DRAFT EDC SIMPLIFIED SCREENING DIAGRAM AND EXPLANATORY NOTES FOR TSRG DISCUSSION ON 6/24/2020

**MA EDC DRAFT FOR CONCEPTUAL DISCUSSIONS ONLY (SIMPLIFIED SCREENS)**

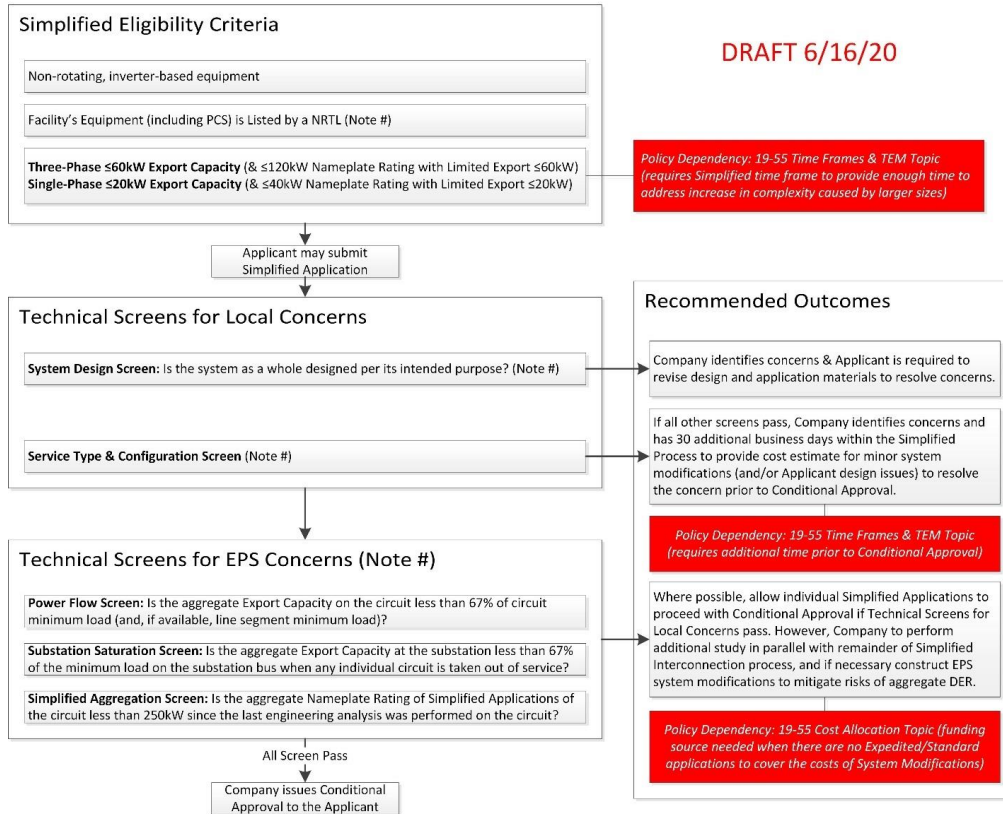
- **Facility's Equipment (including PCS) is Listed by a NRTL** (Note 3 in TSRG proposal for ESS Screening Revisions)
  - **Revised Note:** Facilities with inverter-based equipment will be considered Listed upon demonstrating that such equipment has successfully passed all pertinent tests performed by a NRTL to conform with the latest version of IEEE Standard 1547. IEEE Standard 1547 includes design specifications, operational requirements, and a list of tests that are required for Facilities. IEEE Standard 1547.1 describes how to conduct tests to show compliance with provisions of IEEE Standard 1547. To meet Screen 3 or 4, Interconnecting Customers must provide information or documentation that demonstrates how the Facility is in compliance with the IEEE Standard 1547.1. A Facility will be deemed to be in compliance with the IEEE Standard 1547.1 if the Company previously determined it was in compliance. Interconnecting Customers who can demonstrate Facility compliance with IEEE Standard 1547.1, with the testing done by a NRTL, will be

- **Service Type & Configuration Screen** (Combination of Notes 2 & 6 in TSRG proposal for ESS Screening Revisions)
  - **Revised Note:** This screen includes a review of the type of electrical service provided to the Interconnecting Customer, including the service transformer configuration and service type to limit the potential for creating unacceptable voltage imbalance, over-voltage or under-voltage conditions, or service equipment overloads on the Company EPS due to a mismatch between the size and phasing of the energy source, the service loads fed from the service transformer(s), and the service equipment ratings.

- [Table from Note 6]
  - If the Facility is to be interconnected on a single-phase transformer shared secondary, the aggregate Export Capacity on the shared secondary, including the Facility's Export Capacity, will not exceed 20 kilovolt-ampere ("kVA").

- If the Facility is single-phase and is to be interconnected on a center tap neutral of a 240 volt service, its addition of its Nameplate Rating will not create an imbalance between the two sides of the 240 volt service of more than 20% of the rating of the service transformer.

- **System Design Screen** (Note X in TSRG proposal for ESS Screening Revisions)
  - **Revised Note:** This screen identifies the need for the Company to review the Interconnection Application, and all of the associated material submitted by the Interconnecting Customer, to determine if the proposed design of the Facility as a whole is likely to operate as intended. In particular, the Company will consider the manufacturer's specifications for all the constituent components of the Facility within the context of the site plan, line diagram, operating schedule, project narrative and any other supplemental materials provided by the Interconnecting Customer that may impact the operation of the proposed Facility in Parallel with the Company's EPS. The Company will also consider whether the proposed Facility design as a whole will comply with the Company's technical standards and may also consider (as directed by the Department) whether the proposed Facility design complies with the proposed incentive program(s) identified in the Interconnection Application.

- **Technical Screens for EPS Concerns** (Note 1 in TSRG proposal for ESS Screening Revisions)
  - **Revised Note (for Power Flow):** On a typical radial distribution EPS circuit ("feeder") the annual minimum load as referenced at the protective device at the supply point of the circuit. A circuit may also be supplied from a tap on a higher-voltage line, sometimes called a subtransmission line. On more complex radial EPSs, where bidirectional power flow is possible due to alternative circuit supply options ("loop service"), the normal supply point is the loop tap. If minimum load is not readily available, the minimum load will be estimated by taking a percentage of peak load.

- **New Note (for Simplified Aggregation):** If the aggregate Nameplate Rating of Simplified applications on the circuit is greater than the threshold, a more expansive study is required, but the individual application will not necessarily be held up.
